Columbia Venture, LLC

Appeal to Technical

Information from FEMA

Subject: Congaree River – Lexington and Richland Counties
Appeal to FEMA Presented Information (26 September 2000)

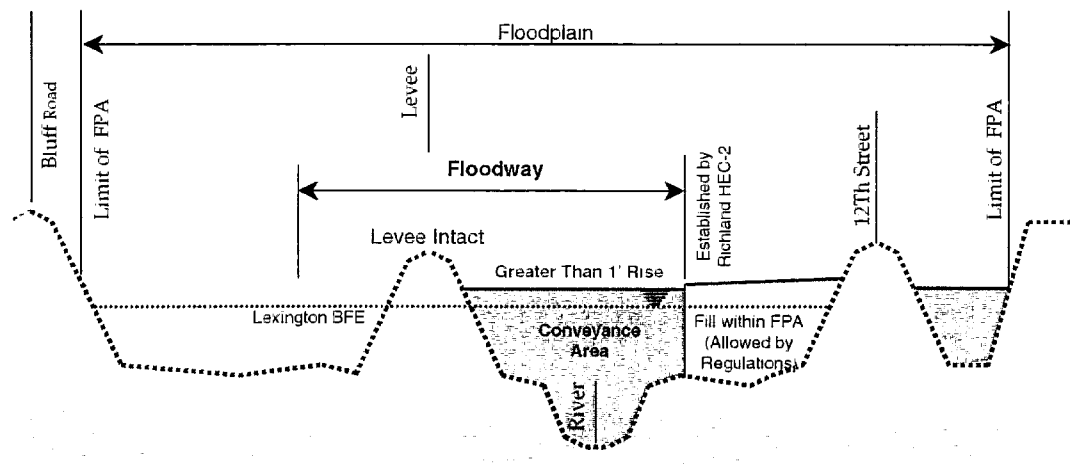
- By using the Richland County HEC-2 model (levee out) for floodway determination increases the risk of flooding.
- FEMA's currently proposed floodway assumes a condition that may not occur, as described below:
 - Flow conveyance occurs for full width of floodway.
 - Levee is removed as a barrier or impediment to flow by the floodway.
 - Richland and Lexington Counties are developed (new construction) to floodway limit.

- The highest potential for flooding exist when:
 - The levee remains intact as barrier to flow.
 - Lexington is fully developed (new construction) to the floodway limit.
 - Flow does not occur for the full width of the floodway.

- In order to maintain 1' maximum surcharge Lexington floodway should be set with levee intact. Use the Lexington HEC-2 model (levee in) for Lexington County Floodway.

Figure 1 – FEMA Hydraulic Grade Elevation

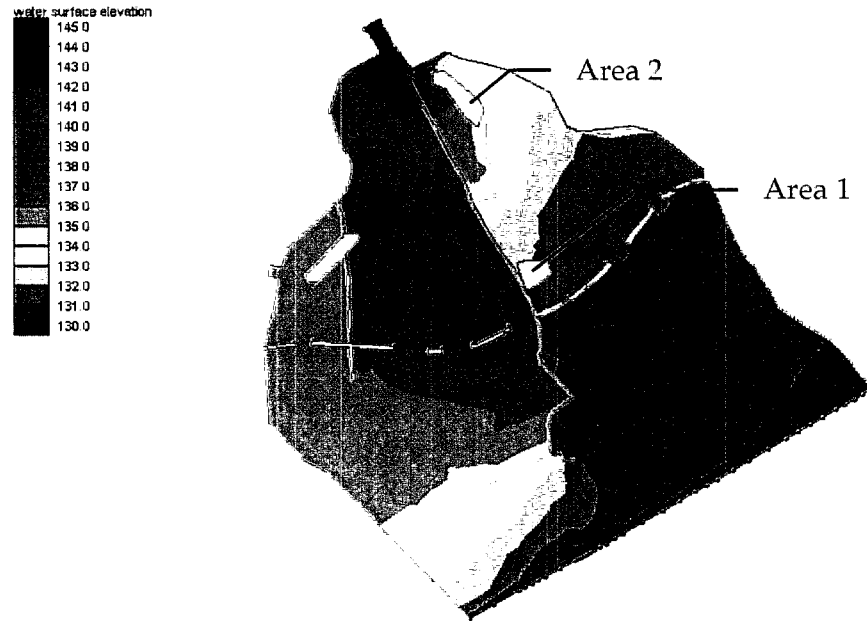
- The area surrounding the City of Columbia WWT facility (noted as Area 1 on Figure 1) is indicated as a wet/dry boundary, but this may not be appropriate since grade at the wastewater treatment plan varies from 127 – 140 feet in elevation. Figure 1 taken from the FEMA provided double piping breach scenario (refin.geo and refin129.sol) files indicate that the water level is approximately 131 to 133 feet; therefore, portions of the area should be excluded from the wet/dry boundary.

- The wet/dry boundary located north of Heathwood Hall (noted as Area 2 on Figure 1) is not appropriate since elevation in that area is approximately 130 feet based on the USGS map (topographic survey is not available). Figure 1 taken from the FEMA provided double piping breach scenario (refin.geo and refin129.sol) files indicate that the water level is approximately 137 to 134 feet; therefore, the area should be excluded from the wet/dry boundary. The removal of this wet/dry boundary will reduce the velocity in the northern area of the levee interior.

Figure 2 - Velocity Less Than 1 Foot per Second at Q = 292,000 cfs

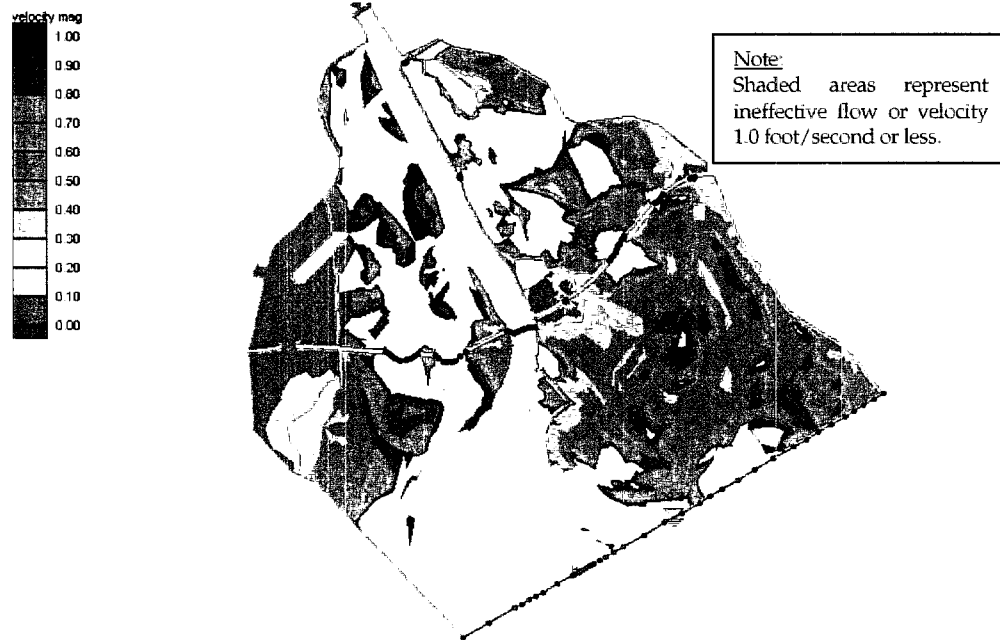
- On page 19 of the “Appeal Resolution for Congaree River in Richland and Lexington Counties, South Carolina” document, effective flow behind the levee is defined as water velocity greater than 1.0 foot per second. Figures 2 and 3 taken from the FEMA provided double piping breach scenario (refin.geo and refin129.sol with $Q=292,000$) files indicate that the water velocity is less than 1 foot per second south of I-77; therefore, portions of the area should be defined as ineffective flow. In fact the areas north of I-77 cannot be considered effective flow when it does not pass through the downstream portion of the property as effective flow.

Figure 4 - North Breach Rating Curve

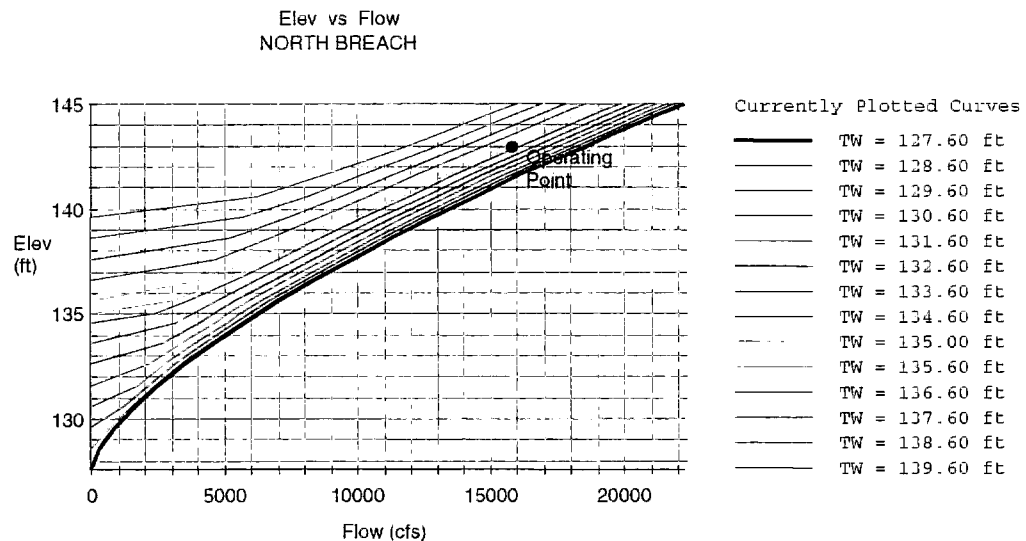
- Flow rates behind the levee from the two models are not consistent.
 - The Richland HEC-2 model indicates a flow rate behind the levee varying between 22894 cfs to 179583 cfs. See the Table 3 above.
 - Lockwood Greene prepared independent calculations based on the geometry and head conditions of the FEMA RMA-2 northern breach (120' wide) that indicates a flow rate of 15900 cfs. The southern breach (120' wide) yielded a flow of 10400 cfs. The

combined total flow through the two breaches is 26300 cfs. See Figures 3 and 4 for rating tables of the breaches.

- It appears that the HEC-2 maximum capacity (22894 cfs) of the I-77 bridges in Richland County approximately matches the breach assumptions (26300 cfs) on the RMA-2 model.
